Access Compliance Report Public Rights-of-Way (Curb Ramps)

Main Street: AIROSO_ST Cross Street: ESENCIA_DR Location: SE

ADA ID: RPRK211129142424 Ramp Type: Type 1 - Perpendicular Initial Pass/Fail: Fail Overall Compliance: No Severity Score: 16

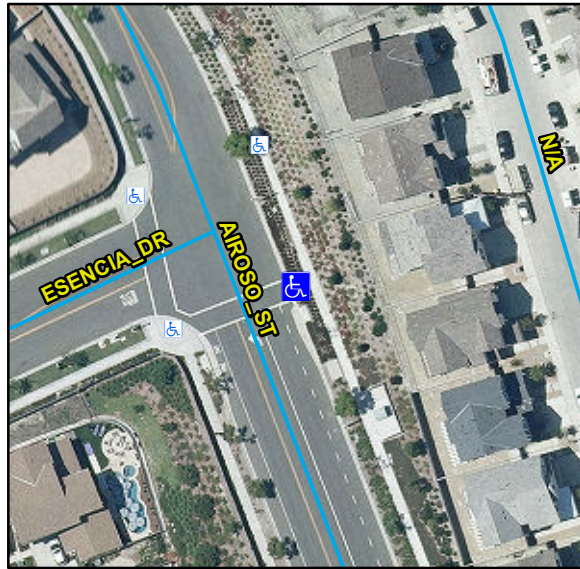
R304.2.2, R304.5.3, STD 1115

Remove & Replace Entire Ramp.
